Design Review Board Meeting
December 1, 2011
Agenda Item: **1**

STAFF REPORT

To: Members of the Design Review Board
From: Associate Planner Tyler
Subject: 91 Sugar Loaf Drive; File No. 711107; Site Plan and Architectural Review for Construction of a New Single-Family Dwelling with a Floor Area Exception
Reviewed By: _____

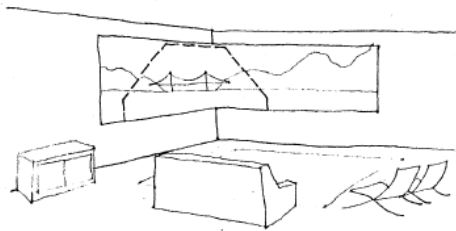
- Goal 3, Principle 7(a) states the view protection is more important for the primary living areas of a dwelling (i.e. living, dining, family, great room, kitchen and decks associated with these rooms) than less actively used areas of a dwelling (i.e. bedroom, bathroom, study, office, den).

• PROPOSED STRUCTURE
BLOCKS LIVING ROOM VIEW -

• GREAT IMPACT ON
LIVABILITY

The proposed dwelling would impact views of Richardson Bay from within the kitchen area of 89 Sugar Loaf Drive.

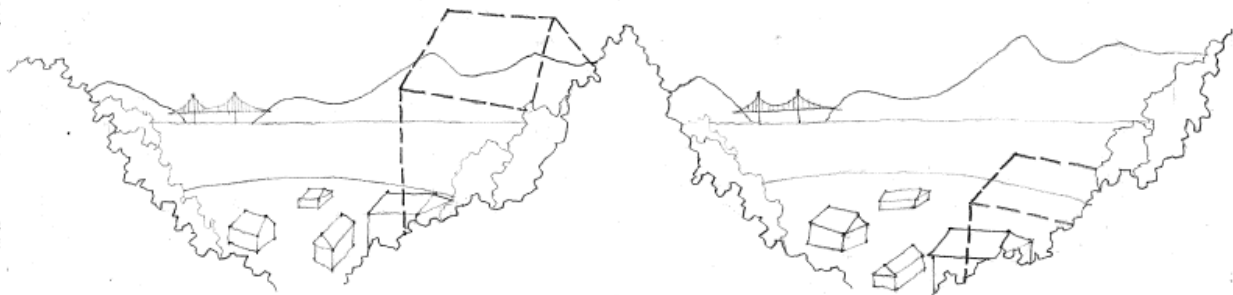
- Goal 3, Principle 7(b) states that the horizon line is the most sensitive part of a view, then foreground, then middleground. If possible, avoid cutting the horizon line of a neighbor's view.

The proposed dwelling would impact the left portion of the foreground and middleground of the view from the kitchen window at 89 Sugar Loaf Drive.

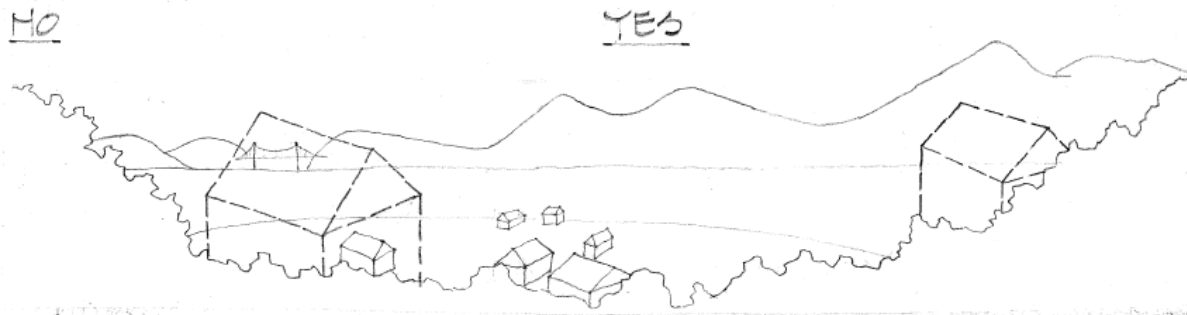
- *Goal 3, Principle 7(c) states that blockage of the center of a view is more damaging than blockage of a side view.*

The proposed dwelling would block the side view of Richardson Bay from the kitchen window at 89 Sugar Loaf Drive.
